PIC16C65A Rev. A Silicon Errata Sheet

The PIC16C65A (Rev. A) parts you have received conform functionally to the Device Data Sheet (DS30234D), except for the anomalies described below.

FIGURE 1: SCK PULSE VARIATION USING TIMER2/2

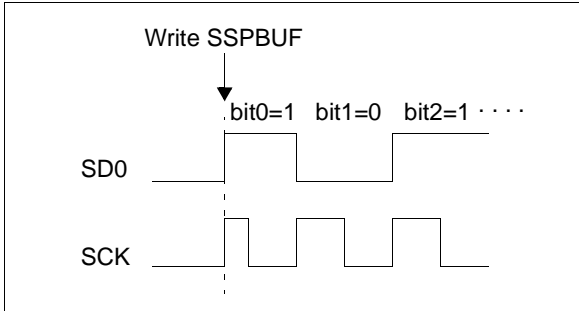
When the SPI is using Timer2/2 as the clock source, a shorter than expected SCK pulse may occur on the first bit of the transmitted/received data (Figure 1).

To avoid producing the short pulse, turn off Timer2 and clear the TMR2 register, load the SSPBUF with the data to transmit, and then turn Timer2 back on. Refer to Example 1 for sample code.

FIGURE 1: WRITES TO TIMER1 (EXTERNAL CLOCK/OSCILLATOR MODE)

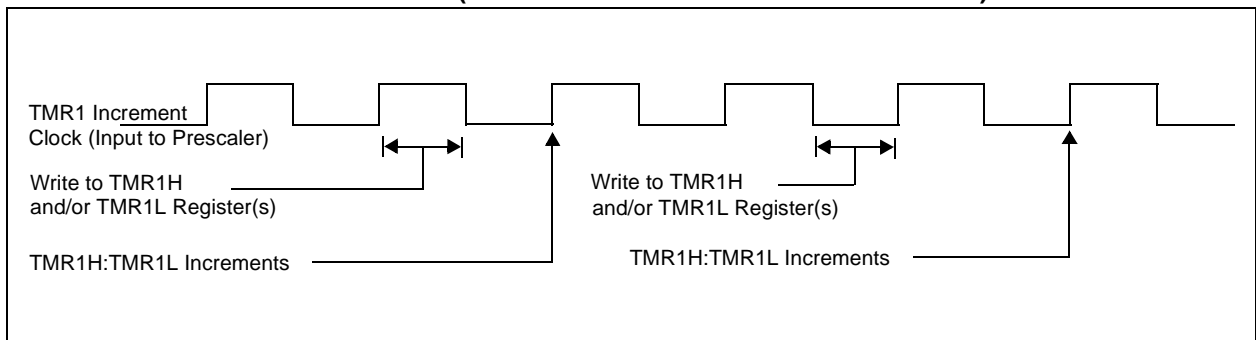
The operation of Timer1 needs some clarification when the timer registers are written and the TMR1ON bit is set.

The internal clock signal, that is the input to the TMR1 prescaler, affects the incrementing of Timer1 (TMR1H:TMR1L registers and the Timer1 prescaler). When the Timer1 registers are NOT written, the Timer1 will increment on the rising edge of the TMR1 increment clock.

When the TMR1H and/or TMR1L registers are written while this clock is high, TMR1 will increment on the next rising edge of this clock.

When the TMR1H and/or TMR1L registers are written while this clock is low, TMR1 will not increment on the next rising edge of this clock, but must first have a falling clock and the rising clock for TMR1 to increment.

Figure 1 shows the two cases of writes to the TMR1H and/or TMR1L registers. Due to the V_{IH} and V_{IL} thresholds on the oscillator/clock pins, external Timer1 oscillator components, and external clock frequency, the Timer1 increment clock may not be of a 50% duty cycle.

The TMR1 increment clock is out of phase of the T1OSO/T1CKI pin by a small propagation delay.
